Access Compliance Report

Public Rights-of-Way (Curb Ramps)

Intersection ID: 48433	Main Street: WHITHORN_WY	Cross Street: SEAMILL_RD	Location: SW
ADA ID: C45F7E050FEC	Ramp Type: PerpDiag	Initial Pass/Fail: Fail	Overall Compliance: No
Severity Score: 25			
Codes/Mitigation Info/Possible Solution		Field Measurements/Component Compliance

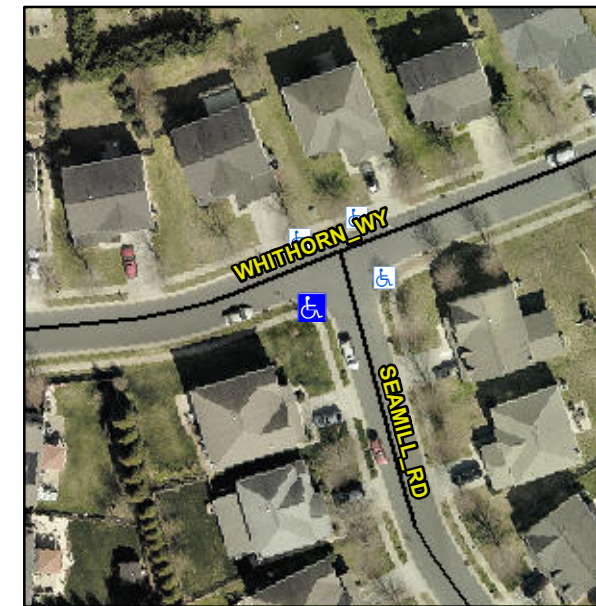
R304.2.2, R304.5.3

Compliance	Description	Data	Compliance	Description	Data
N/A	Ramp Length (in)	47.0	No	Ramp Slope (%)	10.7
Yes	Ramp Width (in)	48.0	No	Ramp XSlope (%)	5.9
N/A	Flare Type LT	N/A	N/A	Flare Type RT	N/A
N/A	Flare Slope LT (%)	N/A	N/A	Flare Slope RT (%)	N/A
N/A	Flare Traversable LT?	N/A	N/A	Flare Traversable RT?	N/A
N/A	Landing Length (in)	N/A	N/A	DWS Provided?	N/A
N/A	Landing Width (in)	N/A	N/A	DWS Contrast?	N/A
N/A	Landing Slope (%)	N/A	N/A	DWS Length (in)	N/A
N/A	Landing X Slope (%)	N/A	N/A	DWS Full Width?	N/A
N/A	Landing Curb? (Y/N)	N/A	N/A	DWS Offset (in)	N/A
N/A	Shared Landing?	N/A			
N/A	Gutter Ponding?	N/A	N/A	Gutter Slope (%)	N/A
N/A	Gutter Lip Ht (in)	N/A	N/A	Gutter X Slope (%)	N/A
N/A	Painted X Walk1?	No	N/A	Painted X Walk2?	No
	X Walk 1 Direction	To E		X Walk 2 Direction	To N
N/A	X Walk 1 Width (in)	N/A	N/A	X Walk 2 Width (in)	N/A
	X Walk 1 Slope (%)	2.7		X Walk 2 Slope (%)	0.9
	X Walk 1 X Slope (%)	0.3		X Walk 2 X Slope (%)	3.8

Remove & Replace Curb Ramp With Two New Directional Ramps or Equivalent.
